AEP-NRC-2009-42
10 CFR 50.55a

Subject: Donald C. Cook Nuclear Plant Unit 1
Response to Request for Additional Information Regarding Relief Request (ISIR-28)
for Use of Weld Inlays as an Alternate Repair Technique for Alloy 82/182 Dissimilar
Metal Welds in Reactor Vessel Safe End-to-Primary Nozzles (TAC NO. MD9997)

Revised Relief Request (ISIR-28) for Use of Weld Inlays as an Alternate Repair Technique for Alloy 82/182 Dissimilar Metal Welds in Reactor Vessel Safe End-to-Primary Nozzles (previously submitted as AEP-NRC-2008-25, Attachment: ISIR-28; Enclosure: Weld Inlay and Potential Repair Weld Inlays for Reactor Vessel Safe End-to-Primary Nozzle Alloy 82/182 Dissimilar Metal Welds Mitigative/Repair Inlay)

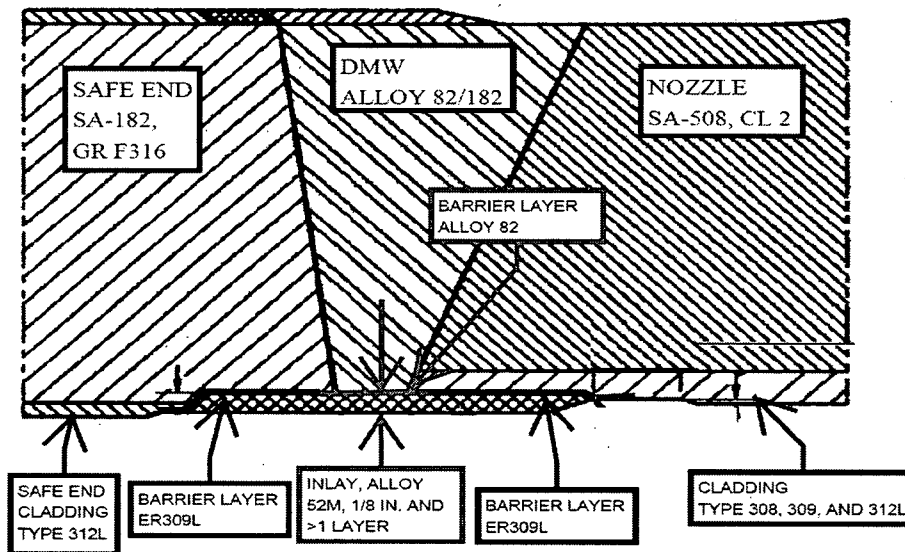
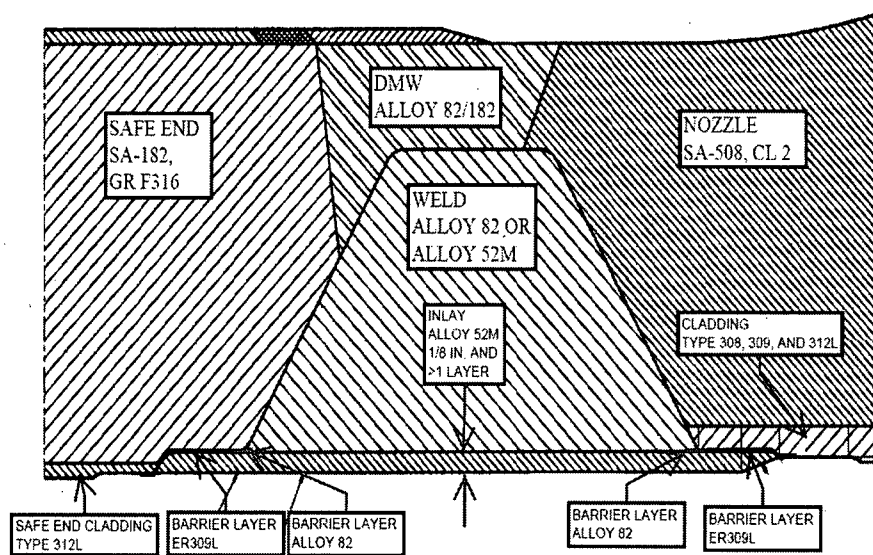
Clarify the application of Alloy 82 and Alloy 52 with respect to their thickness and location in the inlay and DMW configuration. A sketch would help to clarify the question.

Figures 1 and 2 show that stainless steel cladding is located on the inside surface of the low alloy ferritic nozzle. It appears from the figures that Alloy 52M will be welded directly to the stainless steel cladding.

Discuss whether a stainless steel buffer layer will be welded to the cladding prior to welding Alloy 52M. If that is the case, Figures 1 and 2 need to be revised.

See revised Figures 1 and 2 in the relief request.

The stainless steel buffer (Sulfur barrier) will be welded to the stainless steel safe end and cladding. See the sketches provided below. For substantial repairs, Alloy 82 will be used to fill the cavity. For shallow repairs, Alloy 52M will be used. When Alloy 52M is used, Alloy 82 and ER309L will be applied, where applicable, as barrier layers. Figures 1 and 2 were revised in the relief request to show the buffer layer.

A stainless steel barrier layer will be applied over high sulfur-phosphorous stainless steel safe end base material, nozzle cladding, and safe end cladding prior to welding Alloy 52M thereon. Refer to the figures above (3-4(a) response) for the location of ER309L and Alloy 82 barrier layers. Figures 1 and 2 were revised in the relief request to show the stainless steel buffer layer.

Figure E1a – Examination Volume Non-Repaired
Volumetric Examination A-B-C-D
Surface Examination E-F

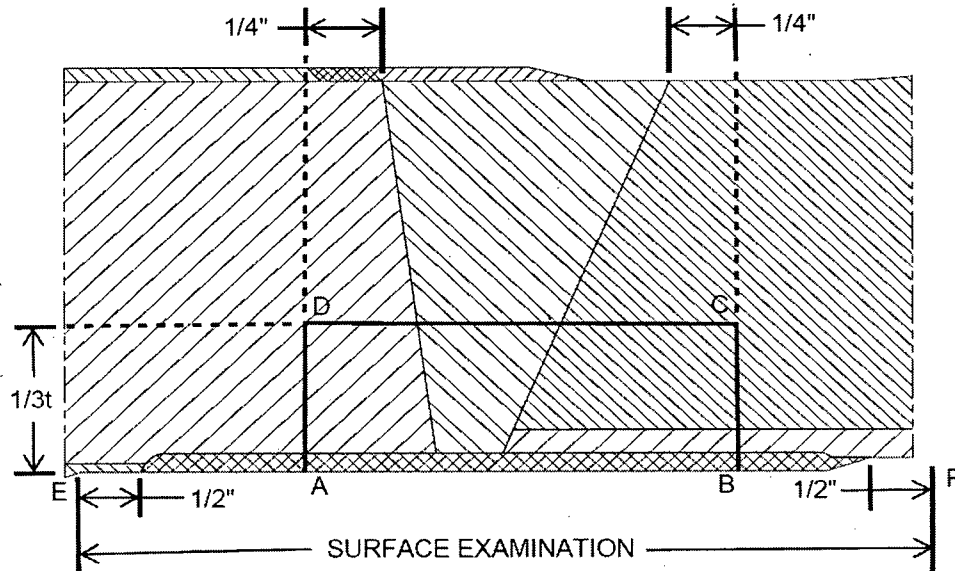
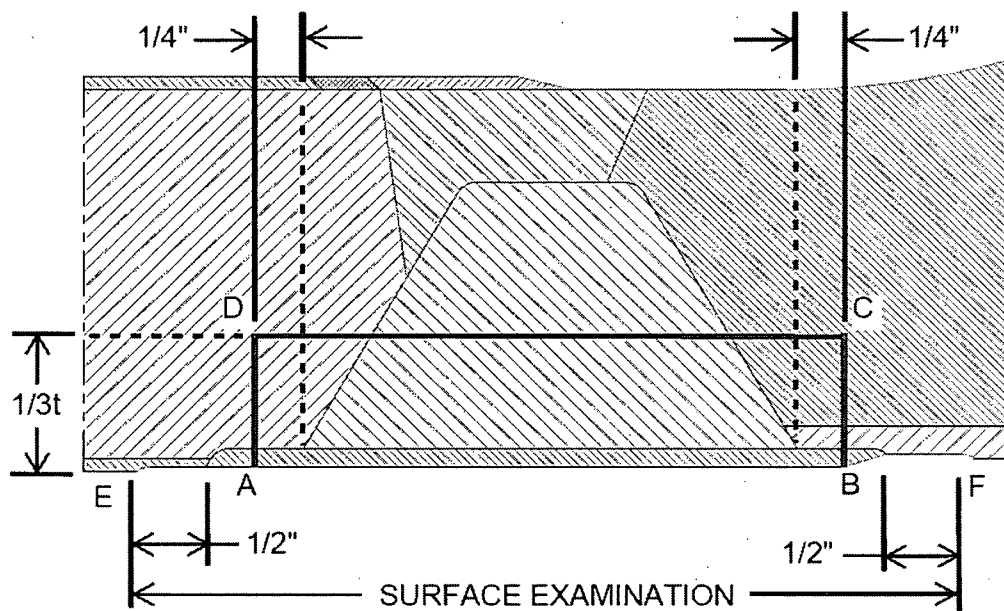
In Figure E1, there are no definitions and specifications for A and B points, and 1/4-inch and 1/2-inch lines.

Provide the basis of the 1/4 inch and 1/2 inch distances. Section 2.0.a.ii does specify 1/4 inches from the DMW fusion zones; however, it is not clear how the 1/4 inch distance discussed in Section 2.0.a.ii is applicable to Figure E1.

Also, please provide the definition and explanation in Figure E1 as footnotes.

material sufficiently. The actual boundaries of the final as-welded deposits determine the examination boundaries. Figure E1 of the relief request was revised to clarify the 1/4 inch and 1/2 inch distances. Volumetric examination and surface examination are described in the revised figure for the non-repaired inlay and the repaired inlay.

Section 3.0.a.vii of Appendix 1 to the relief request has been added to clarify location and states that examinations are performed from the ID. Figure E1 of the relief request was revised to clarify volumetric and surface examination criteria.

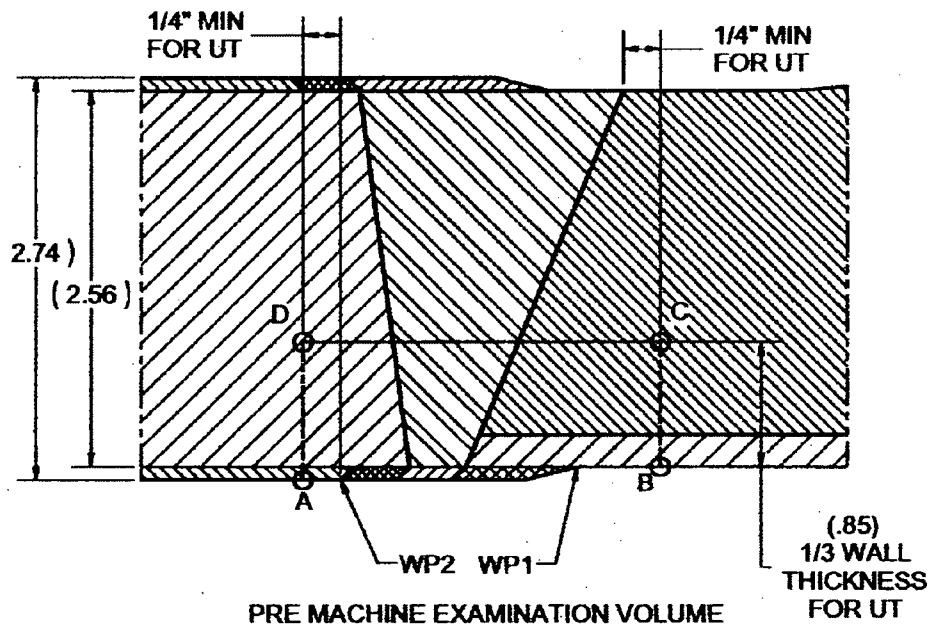
Discuss and provide a drawing of the required UT examination volume in term of specific axial length and volume of the DMWs, safe ends and nozzles.

The pre-inlay examination volume is consistent with the requirements of MRP-139, Materials Reliability Program: Primary System Piping Butt Weld Inspection and Evaluation Guidelines, as referenced in the relief request, and includes the inner 1/3t volume with an axial extent that is 1/4 inch beyond the weld or buttering (as applicable) fusion line measured at the widest point. See the figure below for pre-inlay examination volume (A-B-C-D).

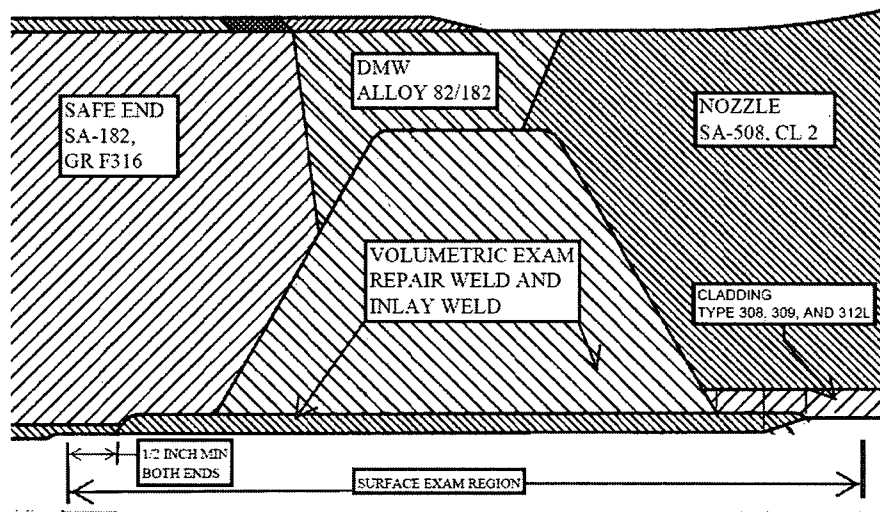
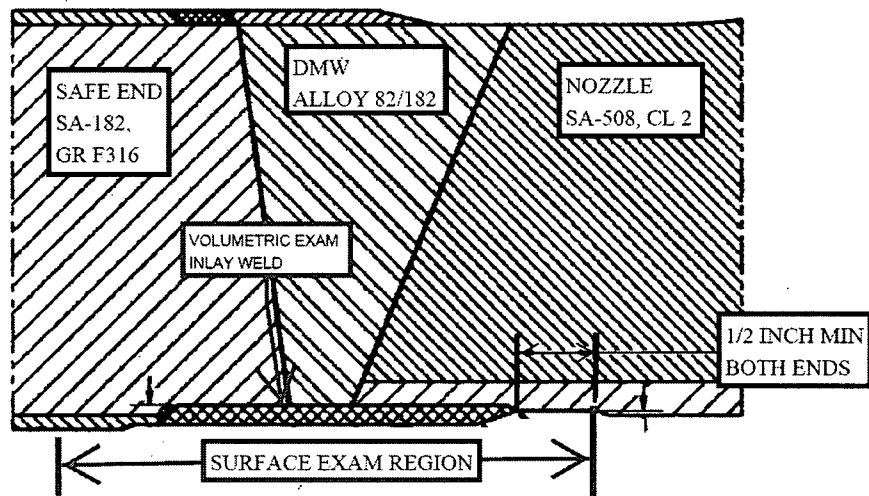
Discuss whether an intermediate PT will be performed after each layer is deposited during inlay installation. If no intermediate PT is required, discuss the reason.

PT will not be performed after each layer is deposited during inlay installation. The welding process will be monitored remotely by installers utilizing a camera system as welding is performed. Any anomalies during the welding process will be corrected upon discovery, if required. The final acceptance and/or preservice UT of the inlay volume will provide adequate assurance of installation. No cracks, lack of fusion, or incomplete penetration are permitted.
